Docket No. 50-537
HQ:S:83:171

NUCLEAR REGULATORY STAFF COMMENTS REGARDING PRELIMINARY SAFETY ANALYSIS
REPORT (PSAR) SECTIONS 9.3 AND 9.13 FOR THE CLINCH RIVER BREEDER
REACTOR PLANT

PSAR SECTION 9.3 ITEMS

PSAR SECTION 9.13 QUESTIONS

FIGURE 3A.9-1

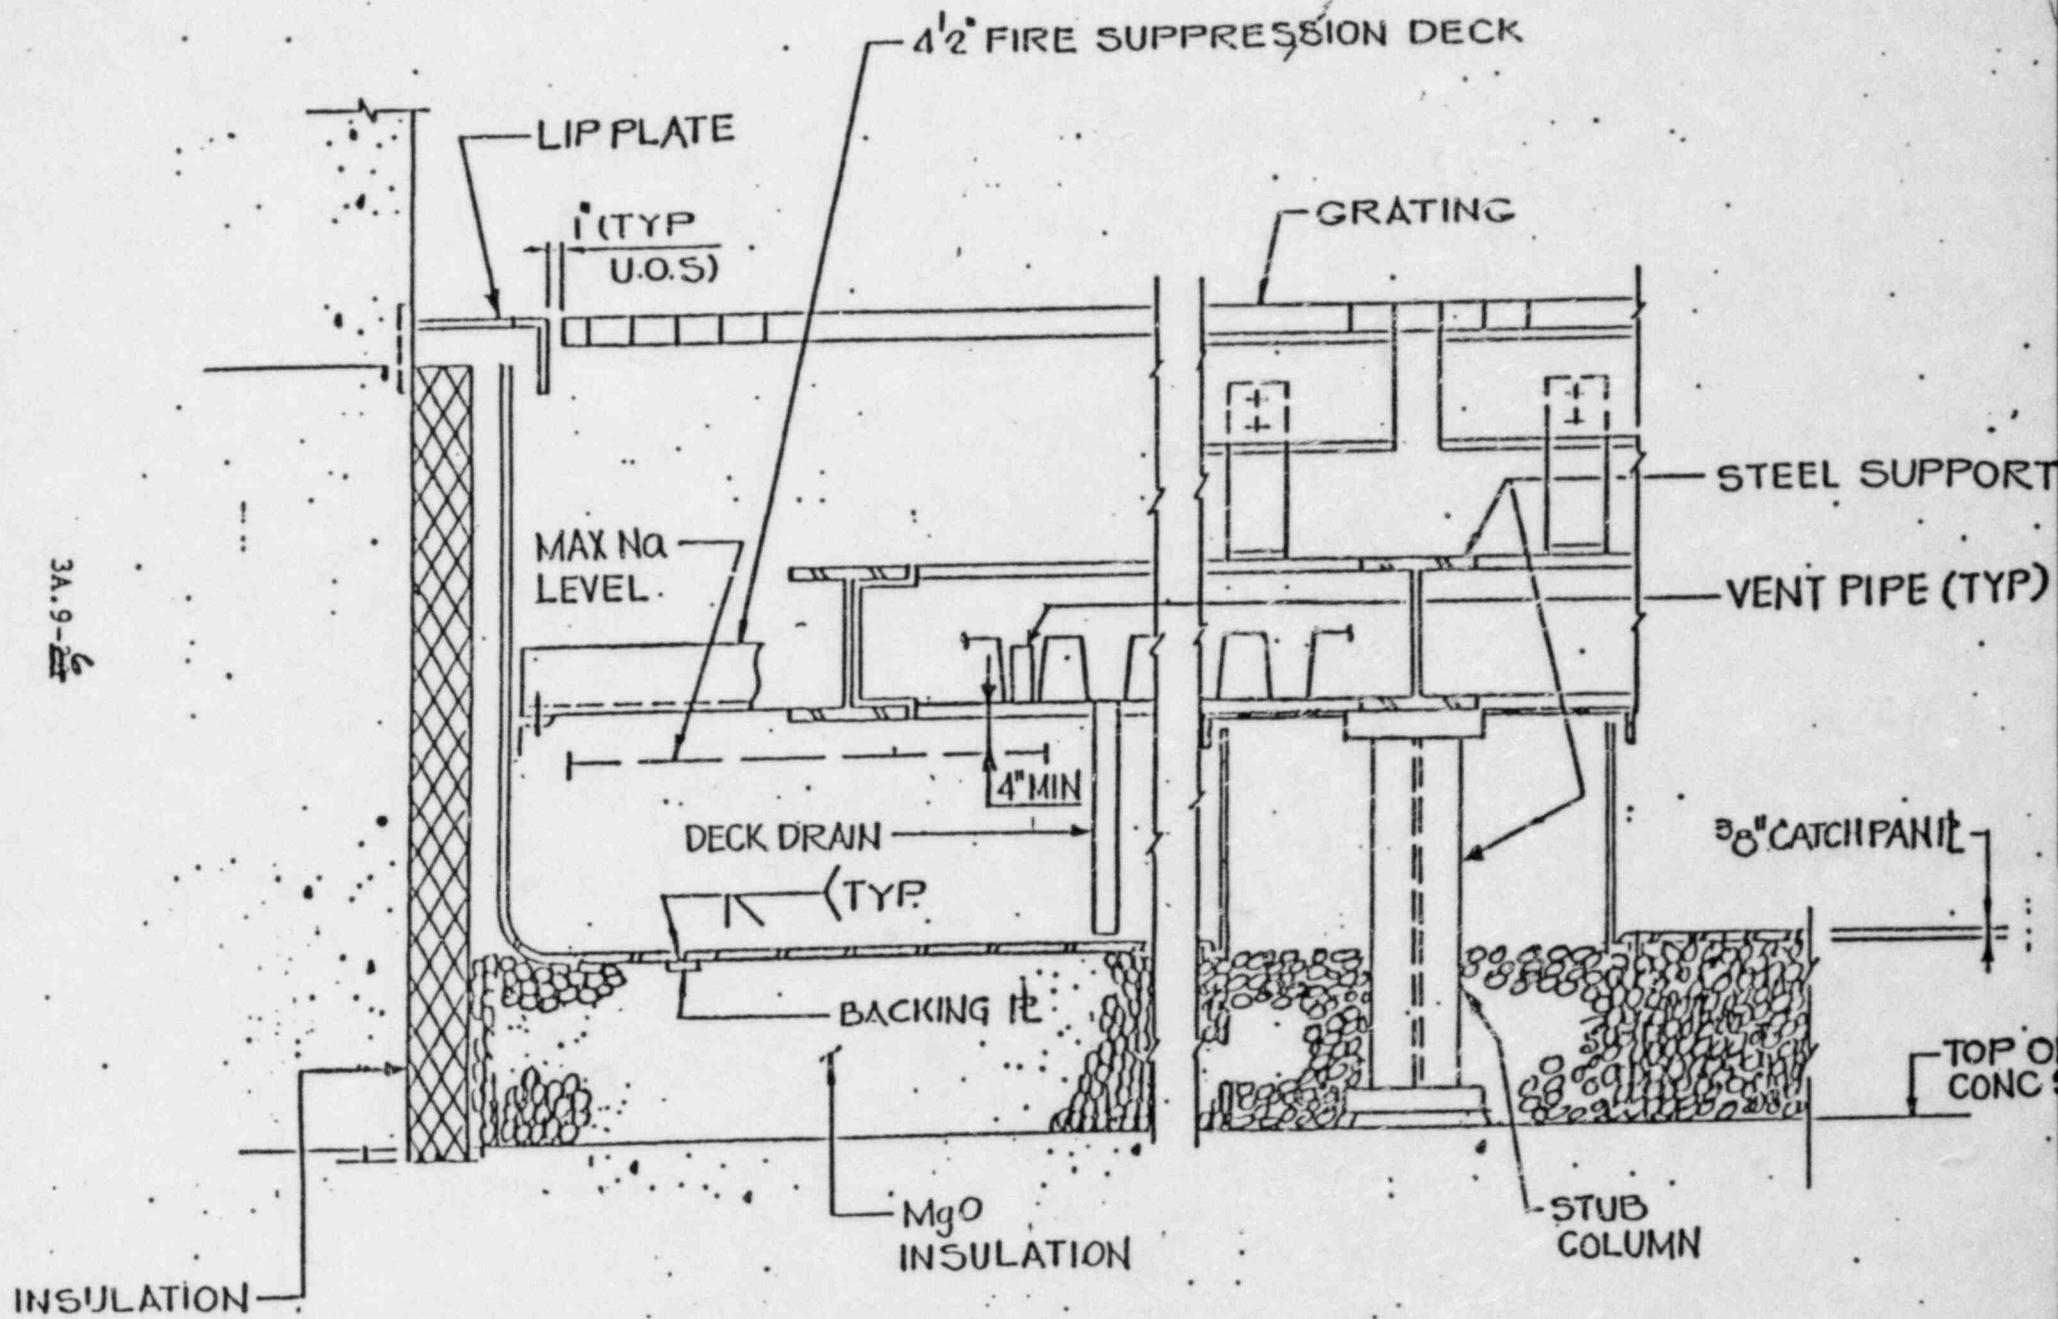
- 9.13-11) No design methods are listed in the PSAR for the catch pan and fire suppression deck design. As discussed in Section 6.5 of the PSAR these methods will be incorporated in a new section of the PSAR to be added in the future (Section 3A.9). This section will require our review.

- 3) The catch pans are free floating and are supported above the concrete floor of the cells by a continuous layer of insulating material (MgO aggregate) and by steel beams. The aggregate being loose and not a solid mass would be subject to settling and have the possibility of producing bending stress in the steel catch pan if the aggregate had settled between the steel beams when a full load of sodium were to occur during an accident condition. Measures should be taken to insure that the aggregate will not settle below the level of the steel support beams or a structural analysis should indicate that the catch pan strength is adequate.

Response: Proposed PSAR Section 3A.9 is attached.

The components of a Catch Pan with Fire Suppression Deck are shown on Figure 3A.9-1 and consist of the following:

In general, the catch pan is "floating", i.e., it is allowed free thermal expansion to minimize thermal stresses. Gaps are provided between the concrete structures and the catch pan side walls to permit the thermal expansion of the catch pan. Around embedments, penetrations, fire suppression deck support columns or other elements attached directly to the concrete structure, a vertical sidewall catch pan plate is provided to permit the free floating catch pan to expand or translate relative to the fixed embedment location without imposing additional load on the catch pan (Figure 3A.9-1).

Figure 9.1-12A EVST Sodium and Nozzle Elevations

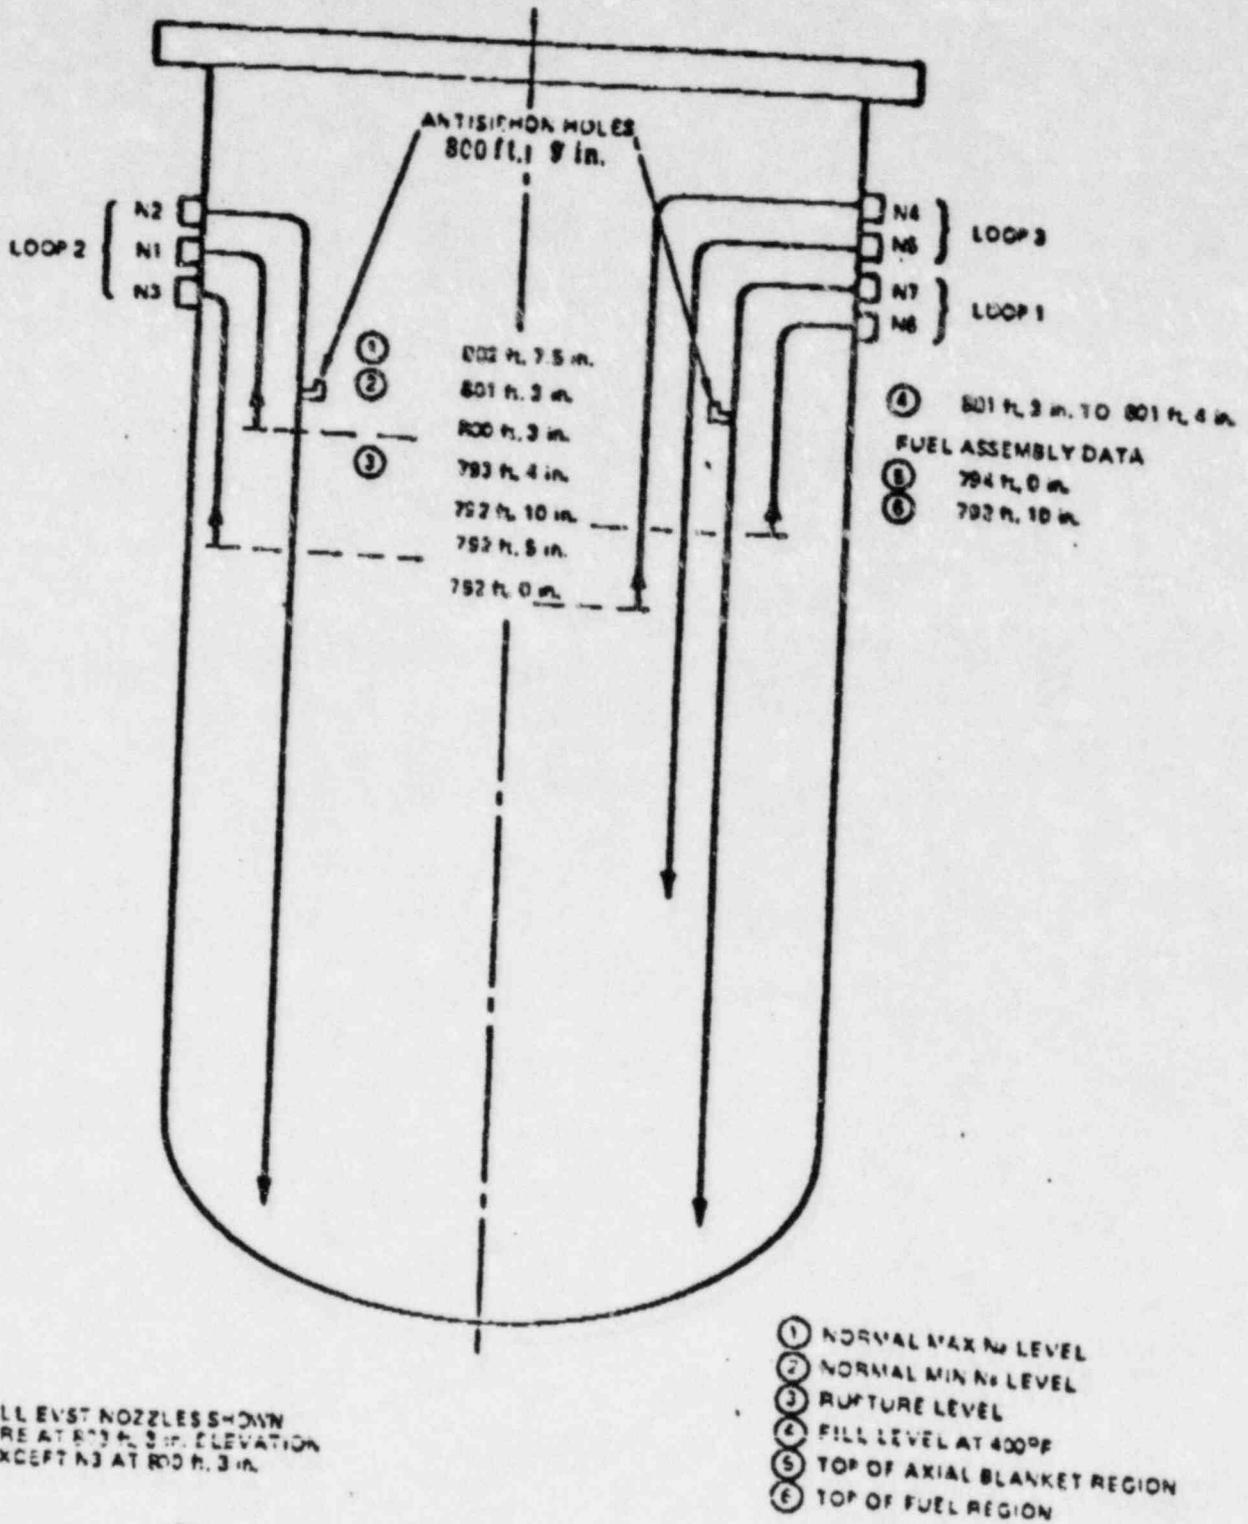
6. Question: Can a leak in the EVS cooling circuits disable cooling of the EVST?

Response: As discussed on PSAR pages 9.1-27, no leak in the EVS system can disable more than one loop. Discussion of the EVST anti-syphon features are provided.

Each of the three sodium cooling loops is designed against the possibility of common-mode failure. Two pump suction lines are provided within the EVST for normal sodium circuit No. 2. The open end elevation of each is different, one high, one low. Each of the two lines is separately valved externally to the EVST. After the initial fill of the loop, the isolation valve in the low suction line is locked closed and remains closed (except for periodic testing) throughout the plant life. This low suction line is used only in the event of a major loop or vessel rupture. One pump suction line is provided within the EVST for normal cooling circuit No. 1. The open end elevation of this line is between those for circuit No. 2. This line is valved externally to the EVST, and is called a "high" pump suction line. During normal system operation, one of the normal cooling loops is operated using the "high" pump suction line. The suction line(s) in the standby normal loops are closed. In the event of a major failure (rupture) of the operating normal sodium cooling loop, the isolation valve in the pump suction line is closed by operator action from the control room, signalled by concurrent alarms, indicating low level
